# UNITED STATES PATENT AND TRADEMARK OFFICE

APPLICATION NO.	FILING DATE	FIRST NAMED INVENTOR	ATTORNEY DOCKET NO.	CONFIRMATION NO.
10/523,155	01/27/2005	Petrus Adrianus Josephus Holten	NL 020713	8386

## Office Action Summary

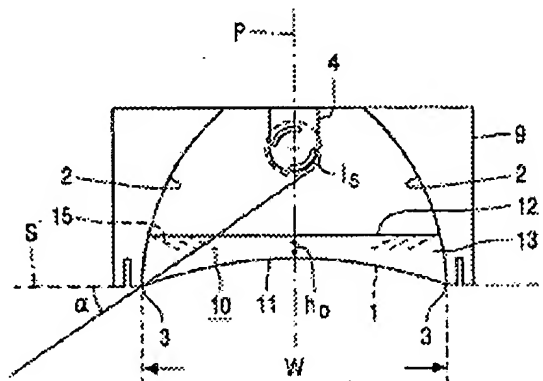
8. With regards to Independent Claim 6, the Applicant defines within the preamble and provides the scope to be confined to a lamellae louver, but recites in lines 5-6 the limitation, "a light-emission window", which renders indefiniteness and confusion. At present, "a light-emission window" is not a part of the lamellae louver, but rather should be a part of the luminaire. It is suggested that the above recitation should read as "a light-emission window of a luminaire", so as to elucidate that the lamella does not have a light-emission window.

10. The following is a statement of reasons for the indication of allowable subject matter: With regard to Independent Claims 1 and 6, the Applicant has sufficiently claimed and defined a lamellae louver, whereby the prior art fails to teach or suggest the combination of structural elements claimed therein, specifically to a distance  $h_0 < 0.1W$  or length of the lamellae (see drawing below), and all dependent claims are allowed.
